TITLE: **2000 North Shoreline Boulevard
(Charleston East)**

The purpose of this Study Session is to present the preliminary plans for the proposed project located at 2000 North Shoreline Boulevard (commonly referred to as Charleston East) and receive Council input on the project prior to the formal application being submitted.

Roof Height Diagram

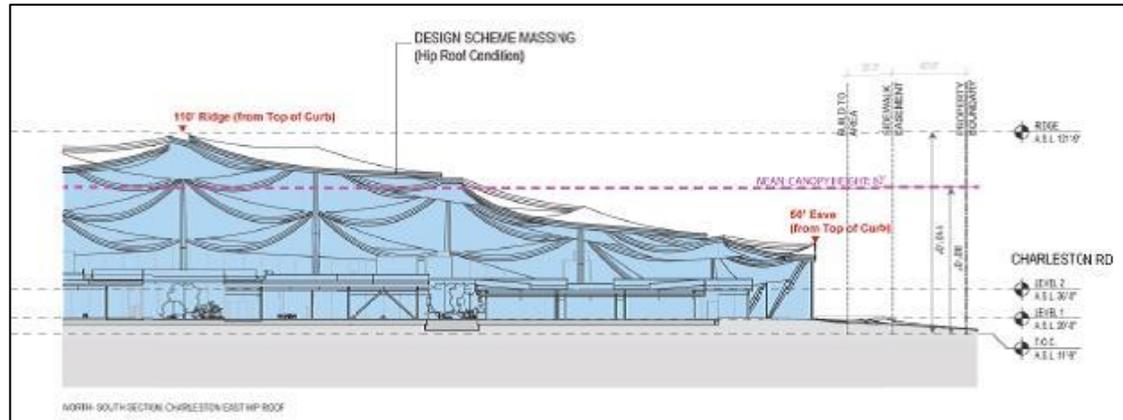
The project's unique canopy structure does not fall into any typical roof-type category. Google believes that their roof design most closely relates to a gable and hipped roof structure for the purpose of calculating height. The highest portion of the canopy structure is 110' and the top of the tallest second floor eave is 50', which results in a mean height of 80', which meets the Precise Plan's height limitation. Staff is supportive of this interpretation and is requesting Council feedback given the unique nature of the building and roof design.

Question 2: Does Council support the 110' height based on the proposed roof height interpretation?
